Subject: Pre-App Notes | P-21-0135 Normandy Heights

CONCEPT SITE PLAN II

PROJECT: P-21-0135/NORMANDY HOMES

PROJECT DESCRIPTION (as provided by applicant): Second pre-app (original P-20-0034). Confirm sewer capacity at Shaw Rd, verify ROW dedication accuracy, verify frontage requirements along Shaw Rd, revised layout review.

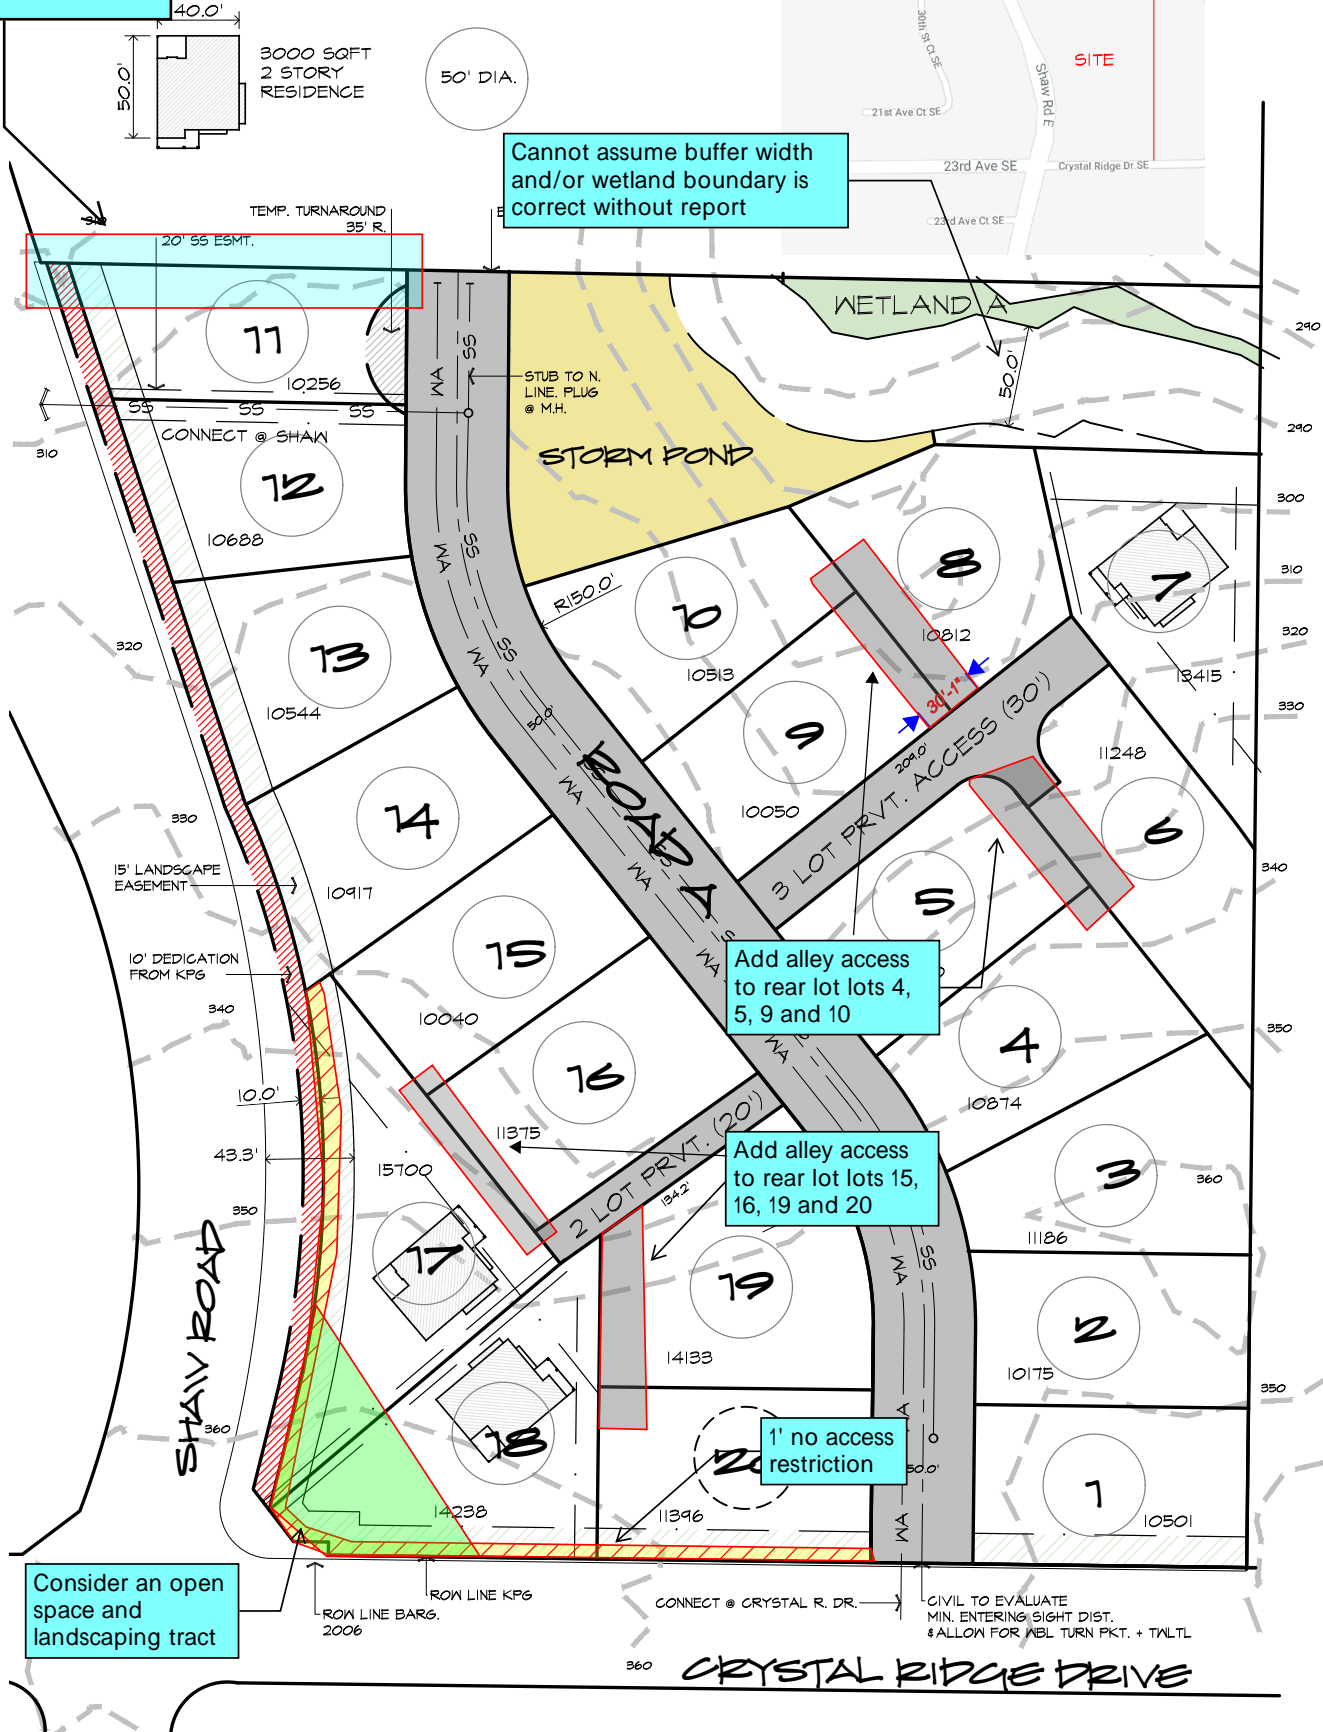
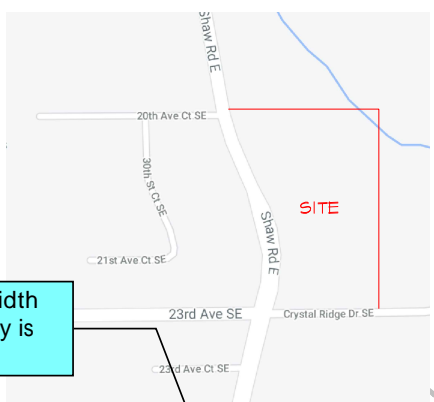
Add ROW alignment for future intersection at 20th & Shaw

Cannot assume buffer width and/or wetland boundary is correct without report

Add alley access to rear lot lots 4, 5, 9 and 10

Add alley access to rear lot lots 15, 16, 19 and 20

1' no access restriction

Consider an open space and landscaping tract
